SERVICE BULLETIN

LANDING GEAR — NOSE GEAR RETRACTION CHAIN — IDLER SPROCKET LATERAL ADJUSTMENT (MOD N840)

NMD-32-21

Figure 1 Rework to Chain Cover

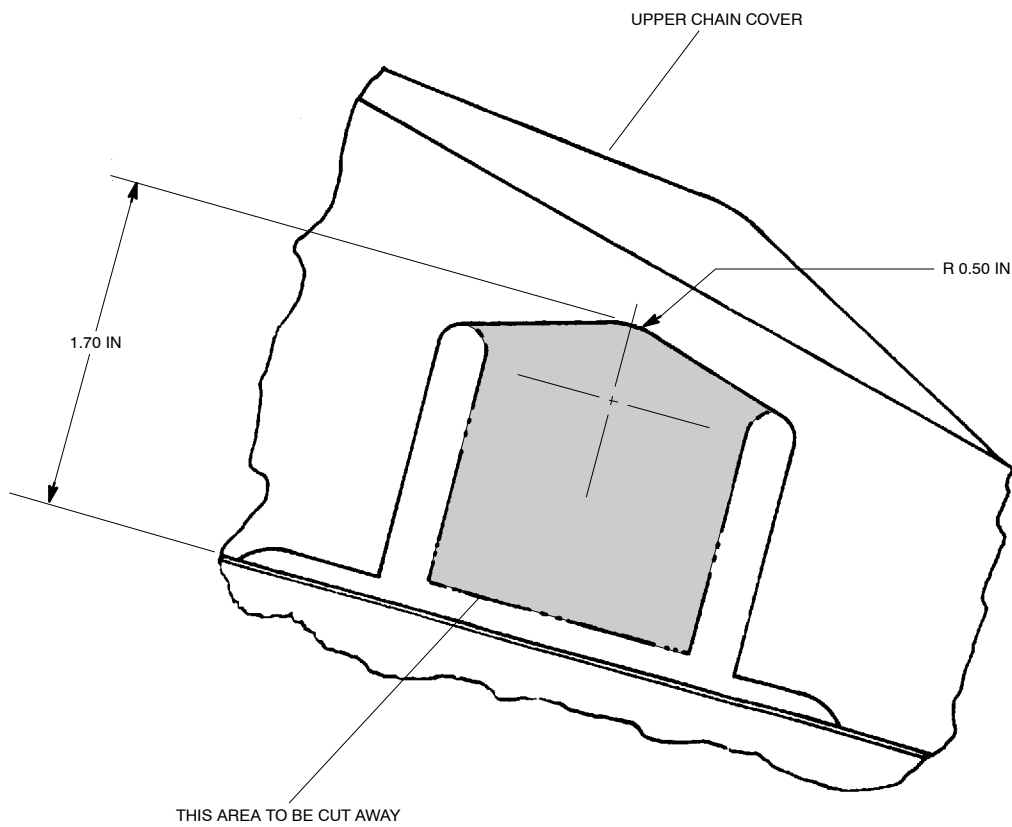
- (2) Ensure that the landing gear ACT, IND and CONT circuit breakers are tripped and the BATTERY switch is set to OFF.
- (3) Remove existing upper chain cover PN 1A/N-03-715, or 1/N-40-949 or 2/N-40-949 (Ref MM Chap 32-30-12) and rework as shown in Figure 1. Deburr edges and apply primer. Re-part number 1A/N-40-954.

Figure 2 Assembly of Idler Sprocket

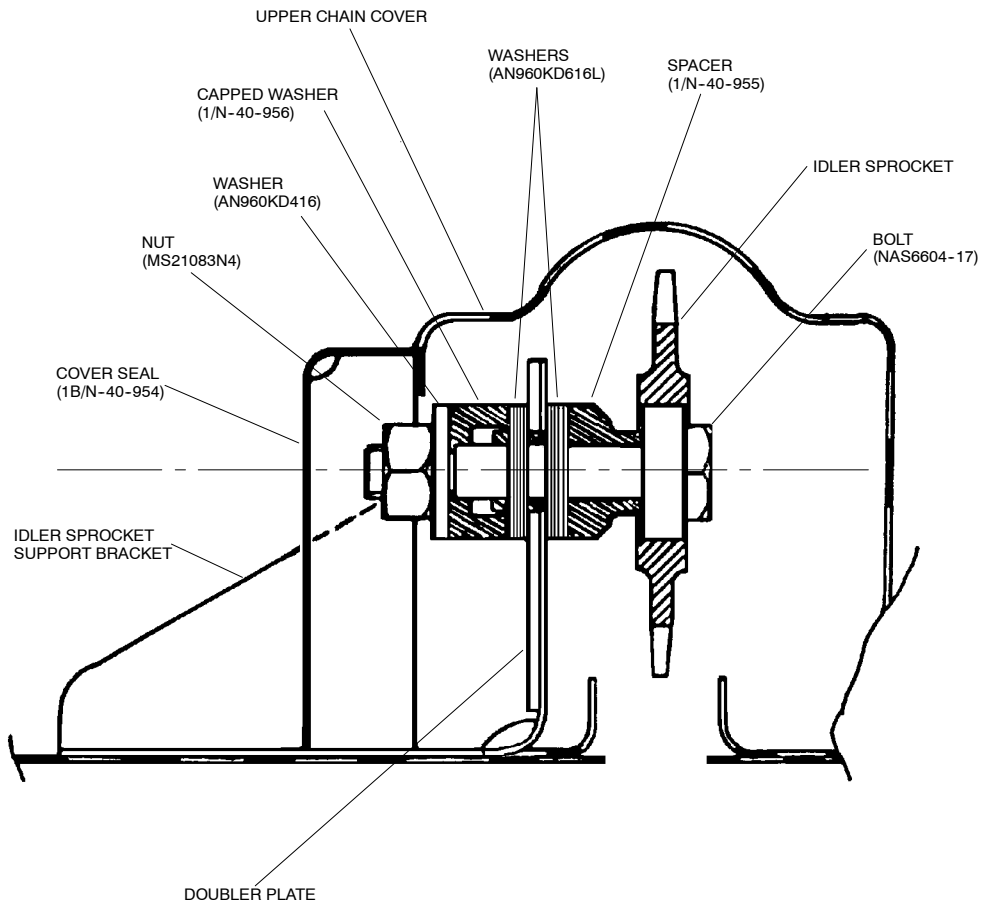
- (4) Disassemble the idler sprocket assembly and discard the spacer (1/N-40-863), bolt (AN174-13A), washer (AN970-4) and nut (MS21083N4).
- (5) Refit the idler sprocket assembly to the mounting bracket using new bolt (NAS6604-17), spacer (1/N-40-955), cap washer (1/N-40-956), flat washers (AN960KD616L), washer (AN960KD416) and nut (MS21083N3) as shown in Figure 2. Using alignment tool (1/N-88-268), (Ref Fig 3) align the idler sprocket assembly with respect to the screwjack sprocket and drive sprocket using the above thin washers. Washers removed from one side of the mounting bracket are to be added to the opposite side to ensure bolt clamp-up. Alignment within 0.008 in (i.e. half the thickness of an AN960KD616L adjustment washer) should be achievable.

Figure 3 Use of Alignment Tool (1/N-88-268)

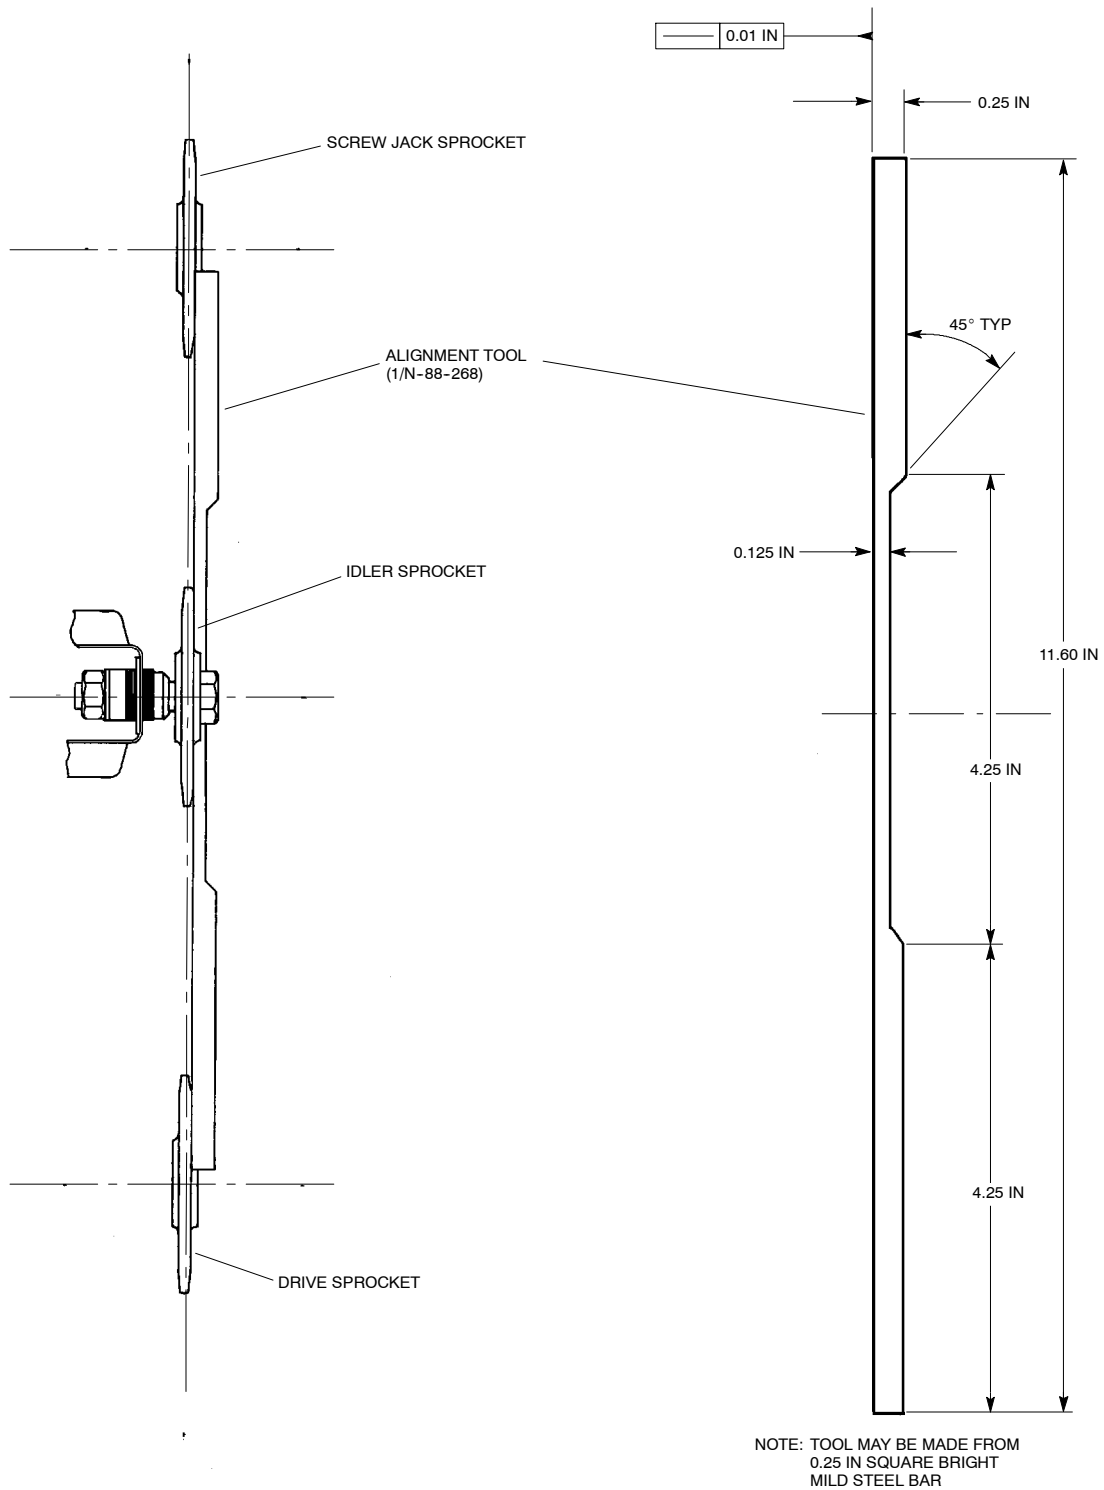
Alignment tool 1/N-88-268 may be manufactured as per Figure 3.
